**AMENDED**

PROJECT	THORPE GREEN HOUSE		
CLIENT	MR & MRS VERRILL THORPE GREEN HOUSE ROBIN HOOD'S BAY YO22 4TW		
TITLE	PROPOSED INTERNAL FLOOR PLANS & EXTERNAL ELEVATIONS		
STATUS	DATE	SCALE	REV
PLANNING	02.05.2012	1:100 / 1:50 @ A1	D
DRAWING NO.	TG PL-03		
THIS DRAWING IS FOR PLANNING PURPOSES ONLY AND NO OTHER USE.			
ALL DIMENSIONS SHOWN ARE PROVISIONAL AND ARE SUBJECT TO ON SITE CONFIRMATION AT THE START OF THE CONSTRUCTION STAGE - ANY DISCREPANCIES ARE TO BE REPORTED TO THE EMPLOYER IMMEDIATELY.			
UNITY CENTRE , 85 BOLE HILL ROAD SHEFFIELD , S6 5DD			
JD

TITLE **EXISTING & PROPOSED SITE PLANS AND  
PROPOSED GATE WIDENING DETAIL**

DRAWING NO. **TGH PL-02**

1:200 PROPOSED SITE ARRANGEMENT

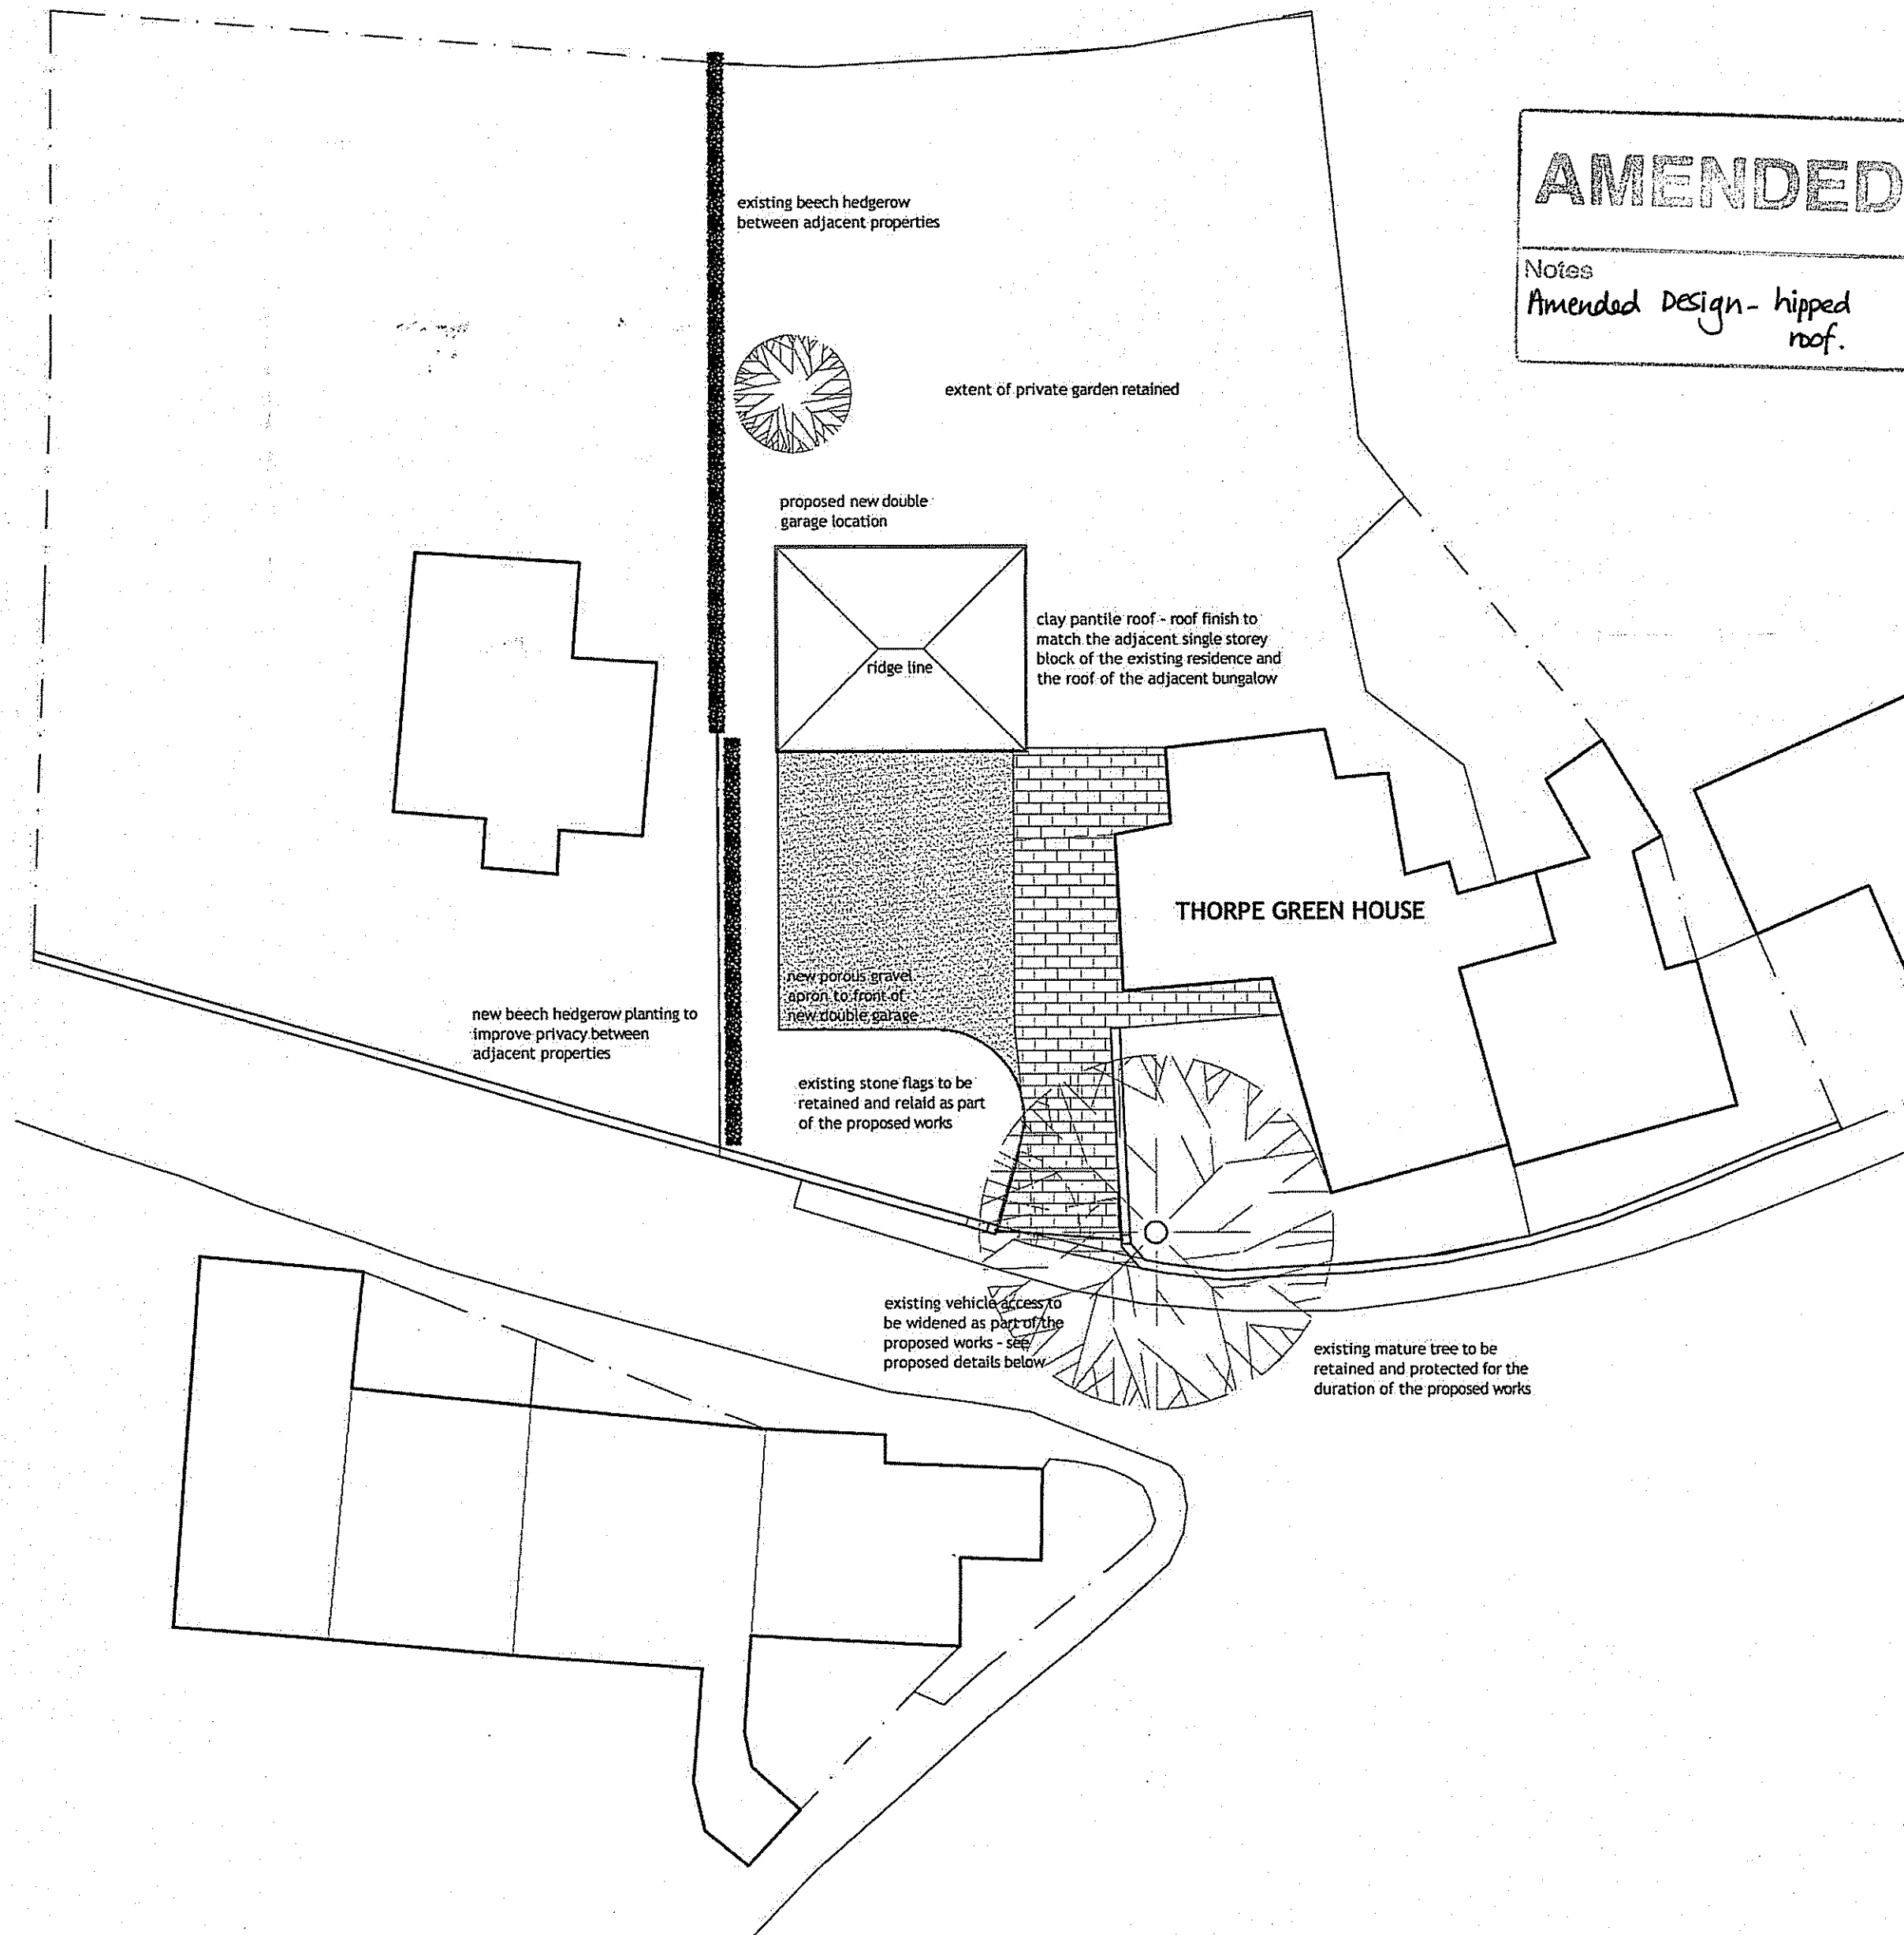
REVISION STATUS:  
REVISION B - 3 AUGUST 2012 - JD  
Hipped roof structure added to double garage to address concerns raised by conservation officer in NYMNP e-mail dated 2 August 2012.  
REVISION A - 18 JULY 2012 - JD  
Proposed double garage relocated and dormer windows removed inline with recommendations received from NYMNP Planning Authority in their letter dated 9 July 2012.
